**ADDENDUM NO. 5  
TO  
CONTRACT DRAWINGS AND SPECIFICATIONS  
Dated July 9, 2007**

**MAINE TURNPIKE AUTHORITY  
ADMINISTRATIVE BUILDING  
CONTRACT NO. 2007.07**

**A/E PROJECT NO. 06016**

**Date of Addendum Issuance: August 17, 2007**

POND EXCAVATION IN LEDGE

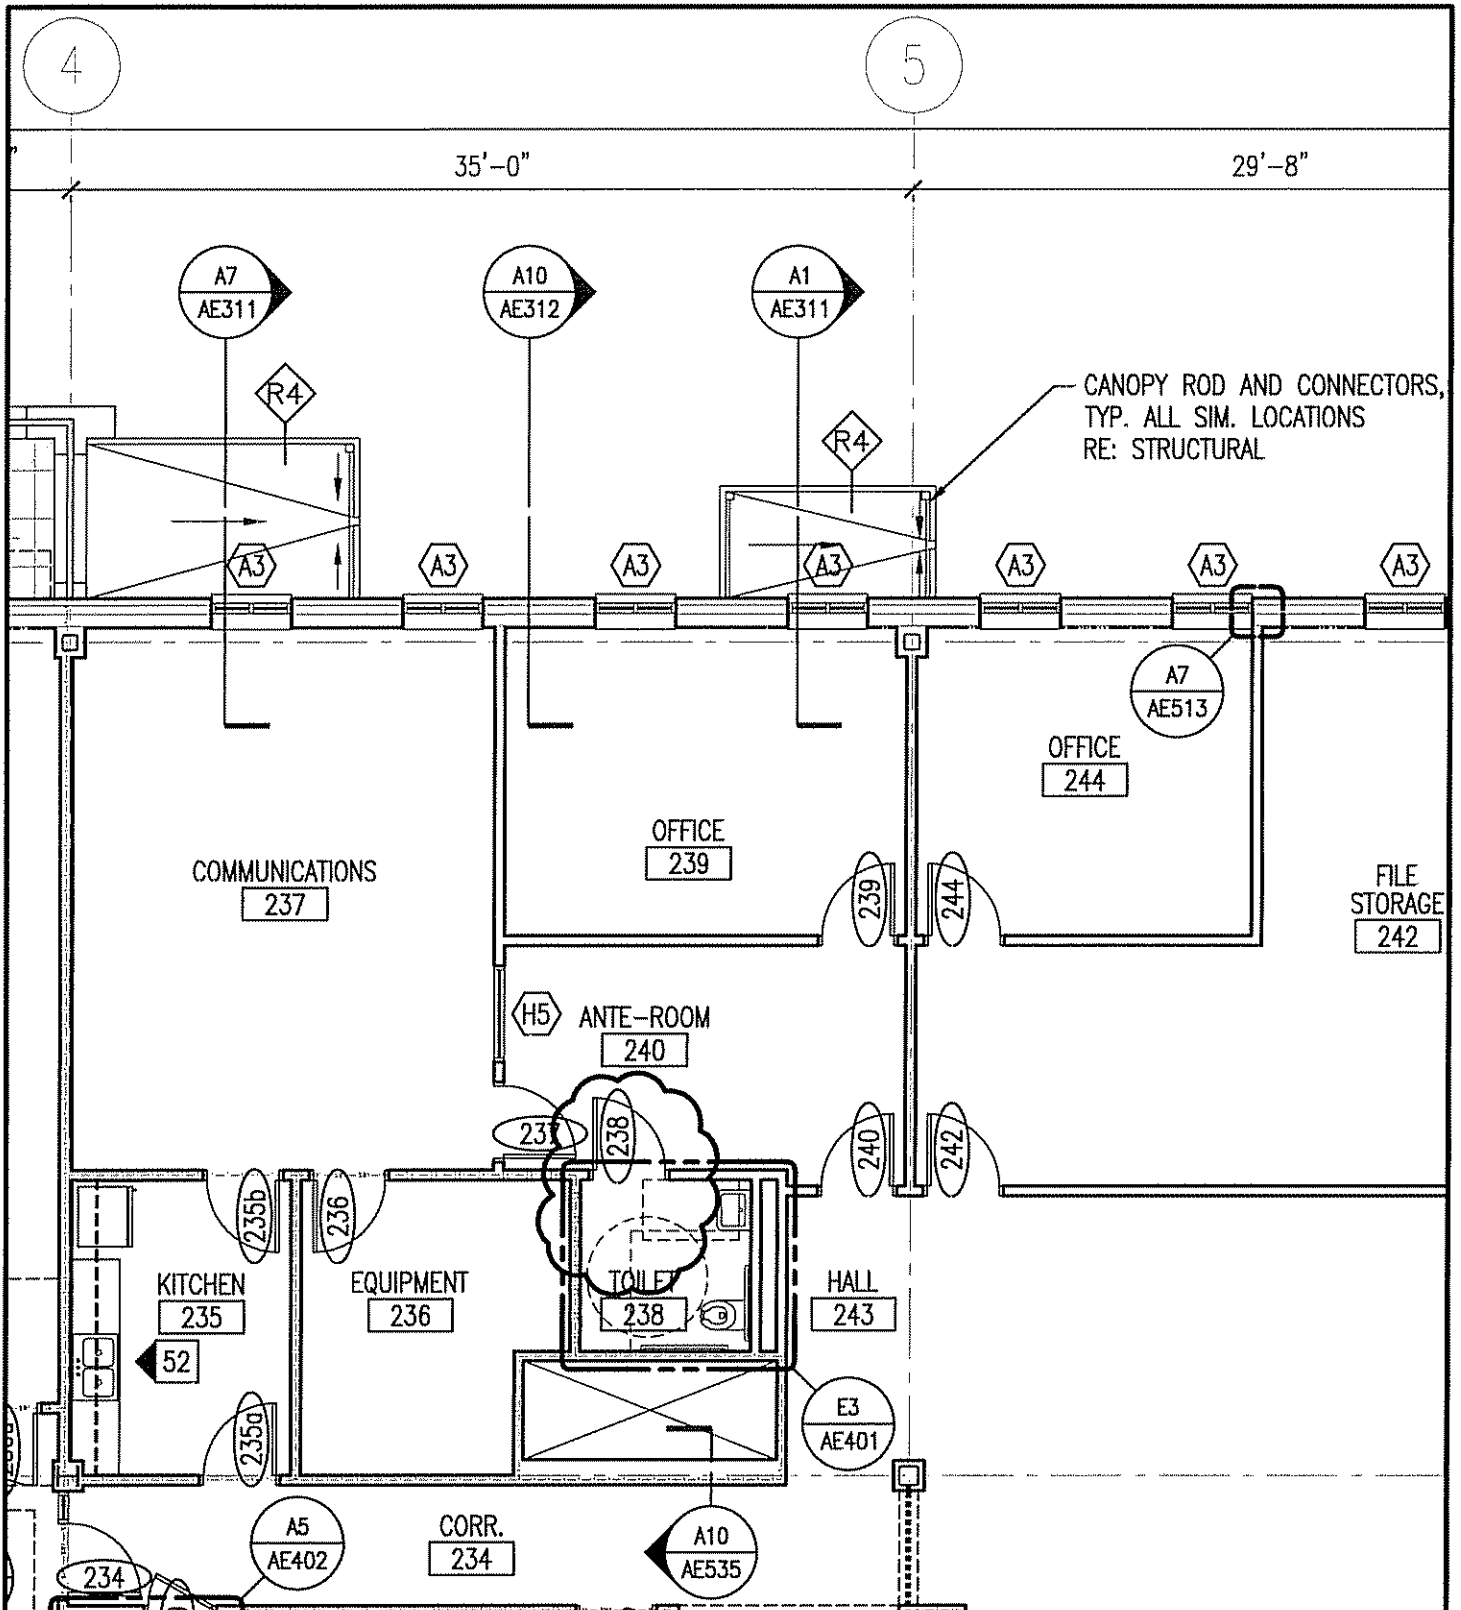
1. CG302 – UNDERDRAIN SOIL FILTER AND DETENTION POND PLANS AND DETAILS:
  - a. Add “SEPARATION DETAIL @ LEDGE” included herein as Sketch No. C-1.
2. AE102 – SECOND FLOOR PLAN:
